ADDENDUM 2 TO ENVIRONMENTAL IMPACT REPORT

Date of Publication of Addendum: March 4, 2026
Date of EIR Certification: June 15, 2017
Case No. **2024-005509ENV**
Project Title: **One Oak Street Project (1500-1540 Market Street)**
Block/Lot: 0836/001, 002, 003, 004, and 005
Project Sponsor: Brynn McKiernan, Emerald Fund, Inc.
(415) 489-1306
Lead Agency: San Francisco Planning Department
Staff Contact: Rachel Schuett – (628) 652-7546
rachel.schuett@sfgov.org

VIEW FROM MARKET LOOKING WEST

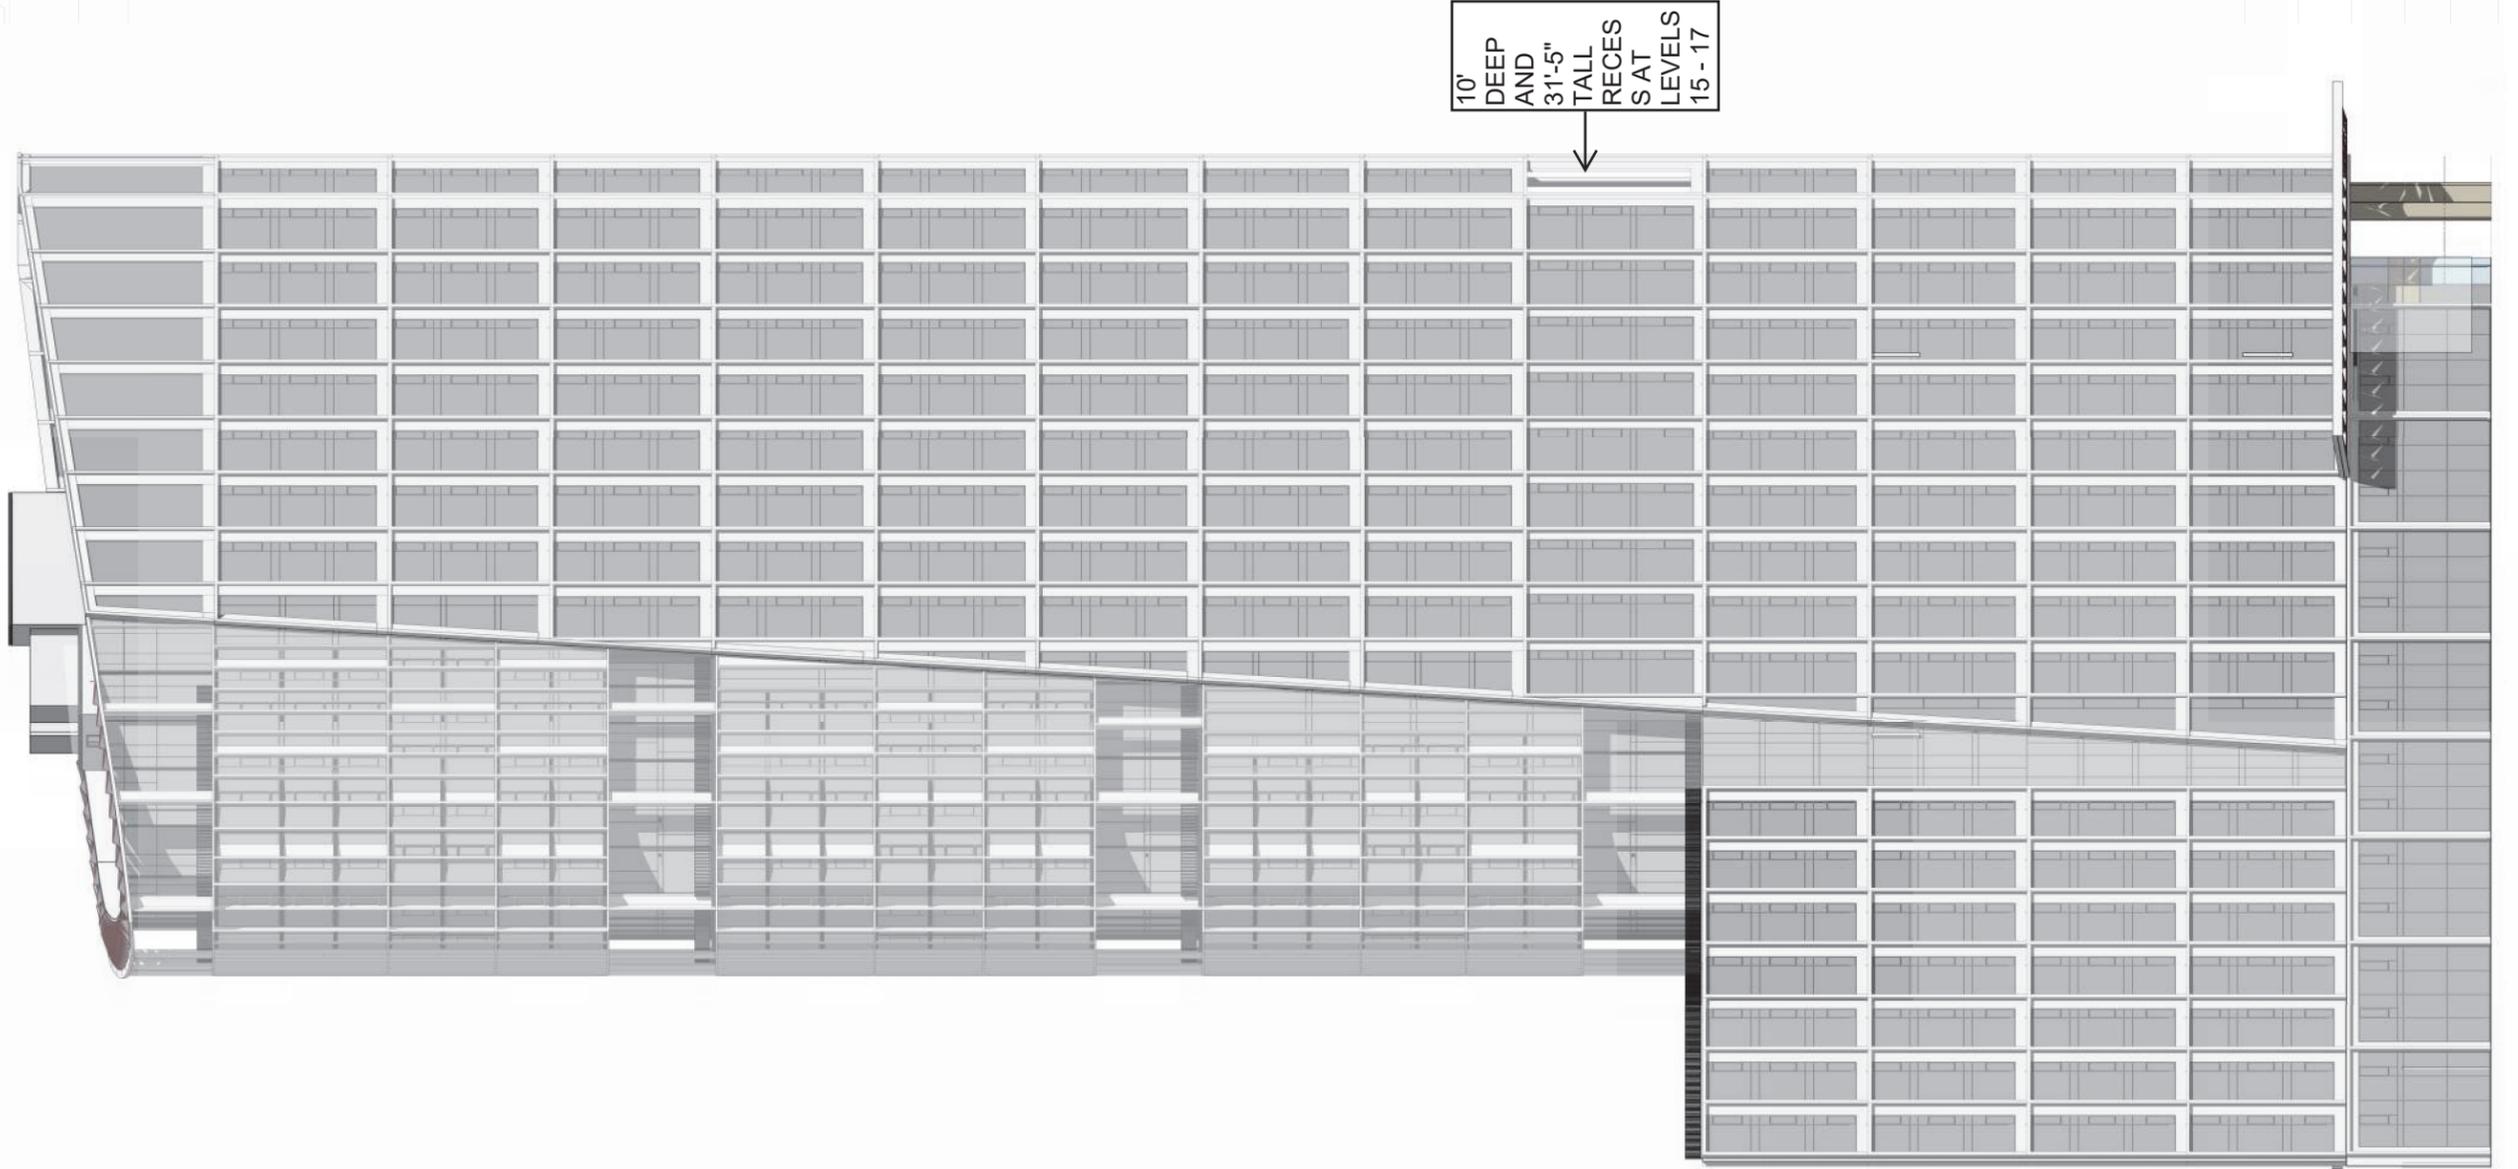
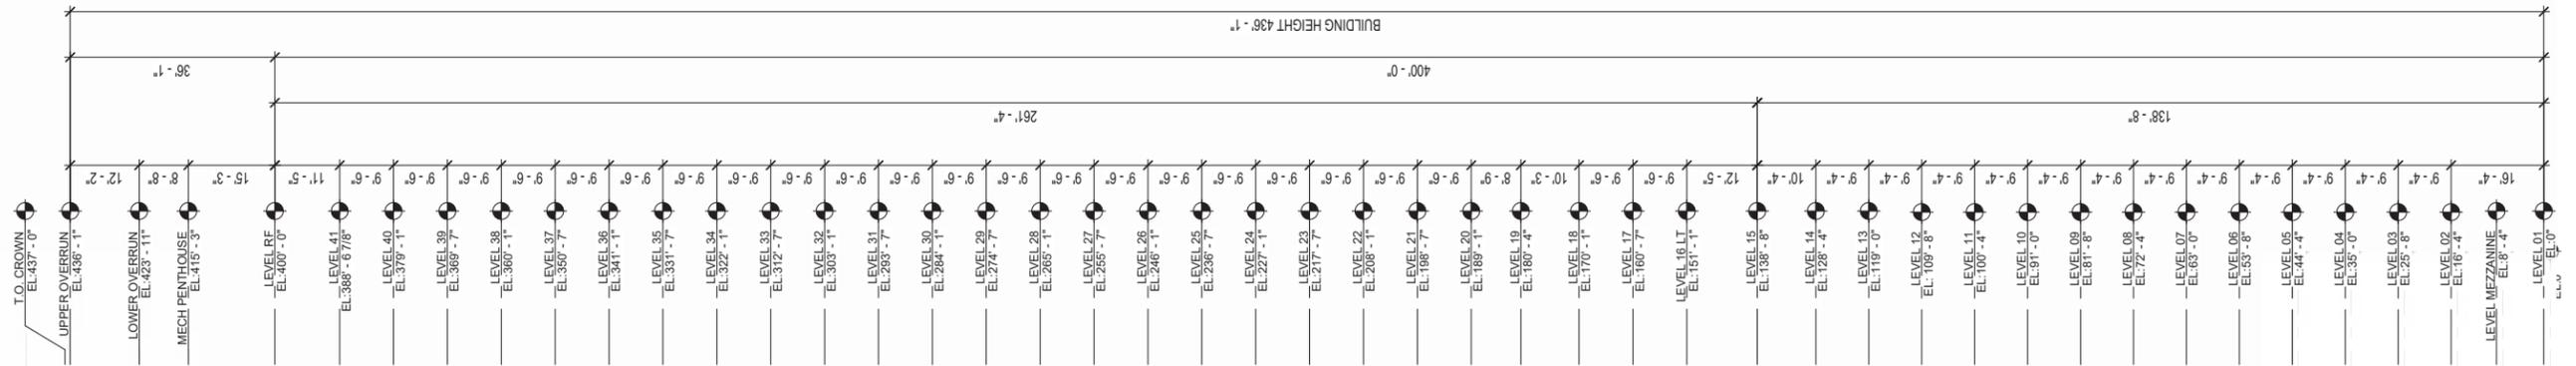
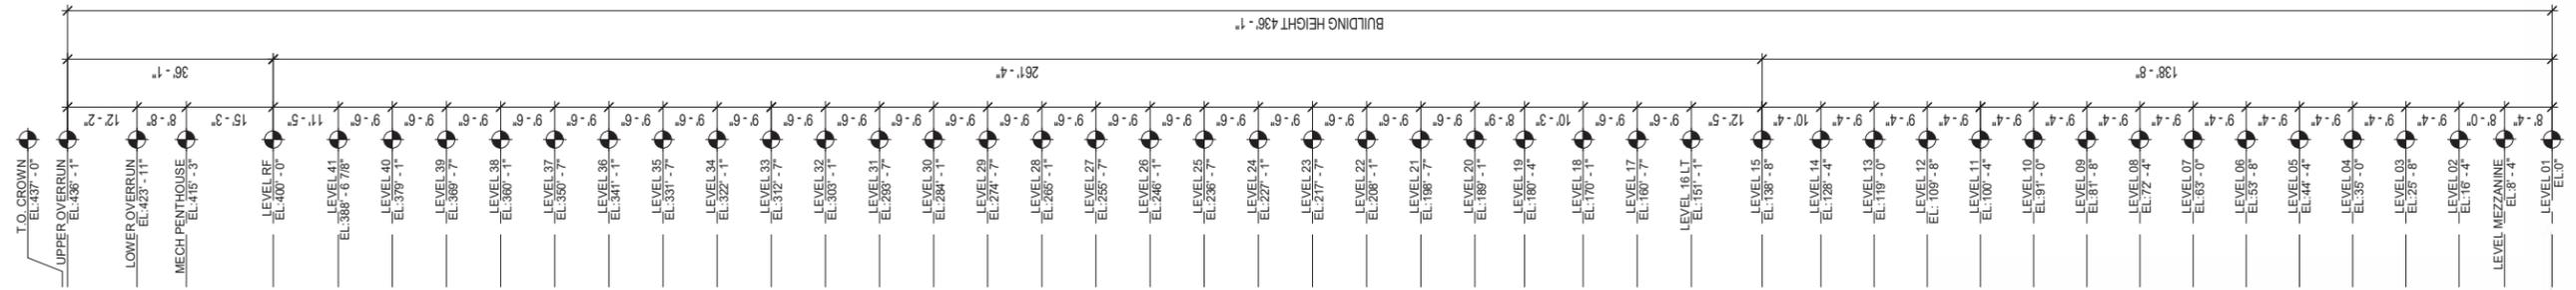
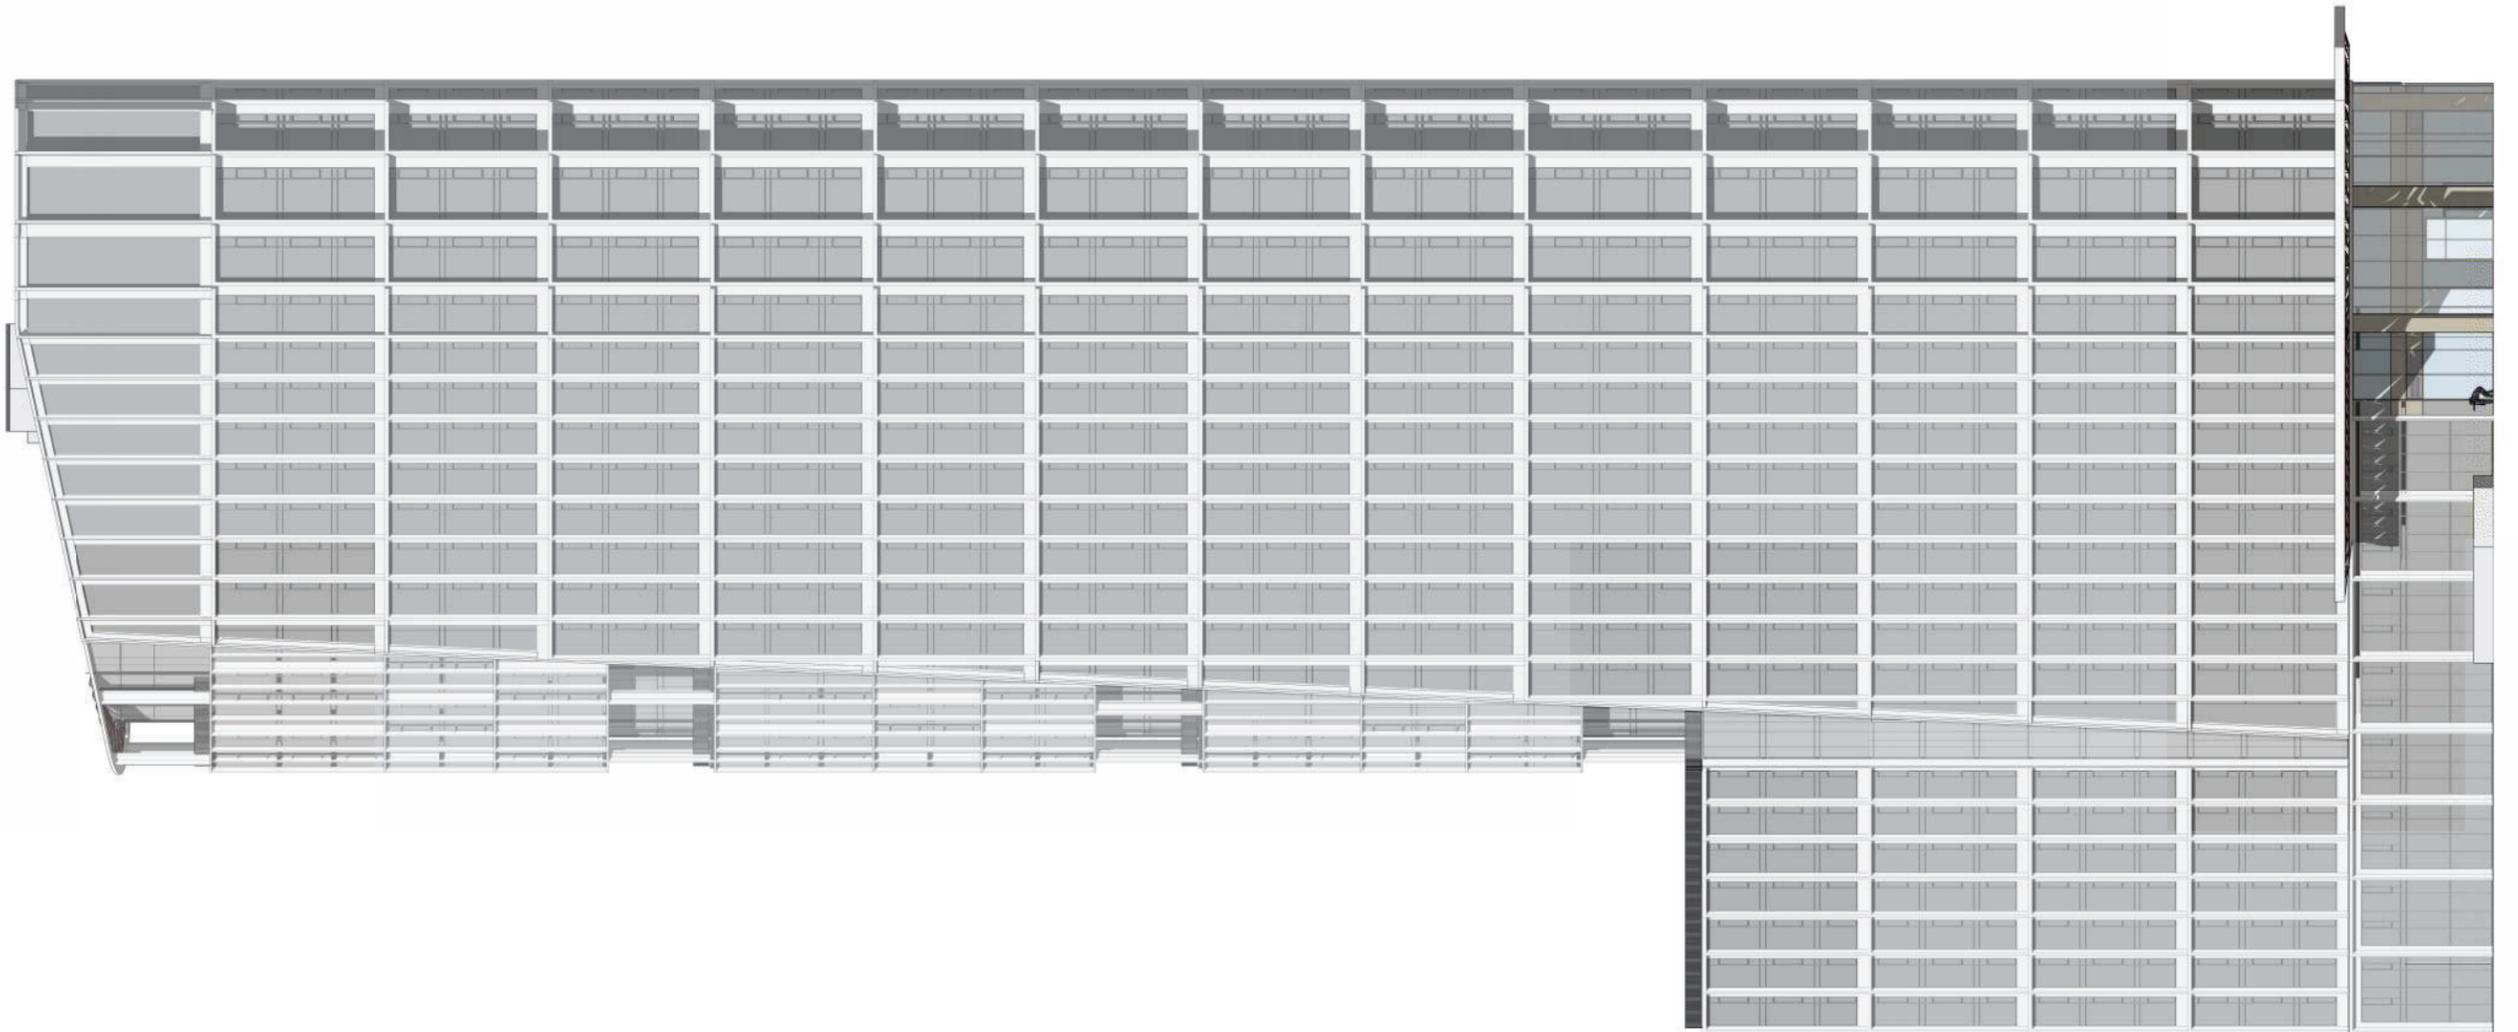
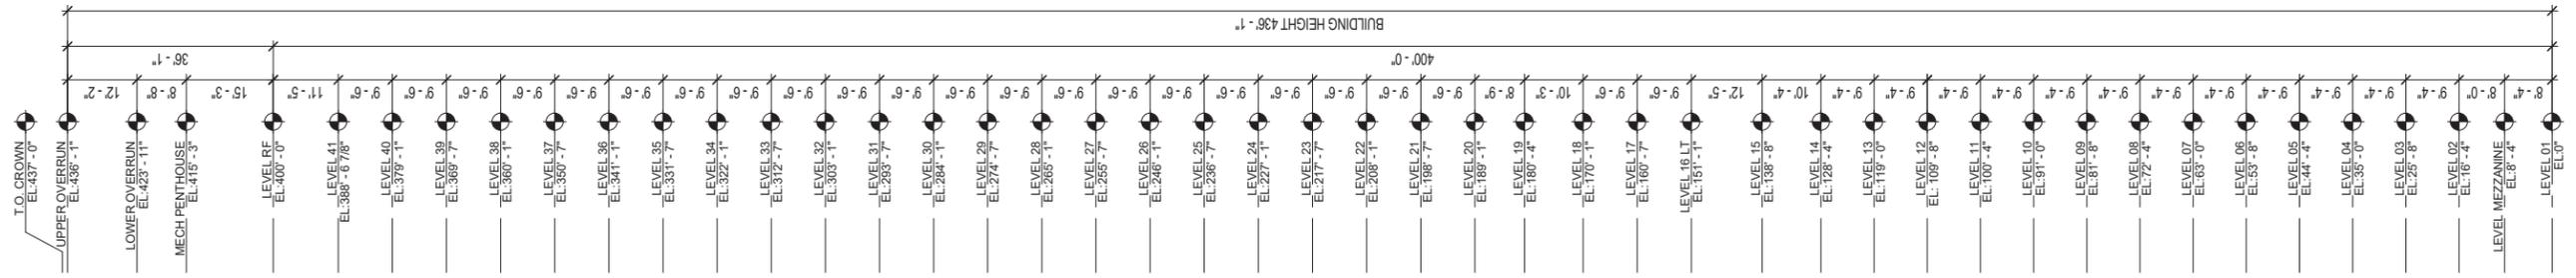
10'
DEEP
AND
31'-5"
TALL
RECES
SAT
LEVELS
15 - 17
